Access Report

**Proposed Classrooms at
Rissalah College**
55 MacDonald Street
LAKEMBA NSW

For: Rissalah College
Ref: LP_22066

Figure 2 | Overall Site Plan

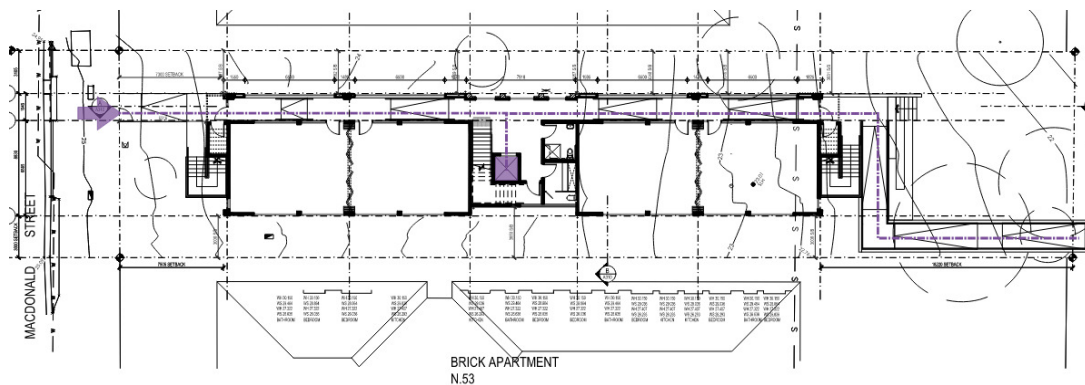
An accessible path of travel is provided to the building entrance from the allotment boundary along McDonald Street. A series of ramps is provided.

An accessible ramp (1:14 gradient) offers an accessible path of travel to the existing college buildings from the new classrooms.

Pathways are a minimum 2100mm wide, with RL's indicating a level surface.

A series of accessible ramps is provided as a part of the proposed development to facilitate an accessible path of travel from McDonald Street to the new classrooms and through to existing buildings within the College. Ramps are also provided at the first-floor level.

Overall configuration of the ramps achieves compliance with current accessibility requirements including nominated gradient of 1:14; provision of landings; and the provision of handrails to both sides.

- a. The minimum unobstructed width of all pathways is to be 1000mm (AS1428.1, Clause 6.3). A width of 1200mm is preferred for compliance with AS1428.2.
- b. All pathways are to be constructed with no lip or step at joints between abutting surfaces (a construction tolerance of 3mm is allowable, or 5mm for bevelling edges).
- c. The maximum allowable crossfall of pathways is to be 1:40.
- d. The ground abutting the sides of the pathways should follow the grade of the pathway and extend horizontally for 600mm. We note that this is not required where there is a kerb or handrail provided to the side of the pathway.

- a. Ramp to comply with AS1428.1, Clause 10.3. Maximum allowable gradient of the ramp is 1:14, minimum clear width to be 1000mm and maximum length between landings to be 9m (for 1:14 gradient).

- b. Accessible ramp is to have a maximum rise of 3.6m (BCA Clause 3.11).
- c. The ramp is required to be set back a minimum 900mm from the property boundary (AS1428.1, Clause 10.3 (f)). This allows tactile indicators and handrail extensions to occur within the boundary and not protrude into the footpath area.

- d. Provide handrails, with extensions, to both sides of the ramp to comply with AS1428.1, Clause 12. Handrails to have an external diameter between 30-50mm to assist persons with a manual disability such as arthritis. Handrails are required on both sides of the ramp to cater for left and right-handed disabilities.
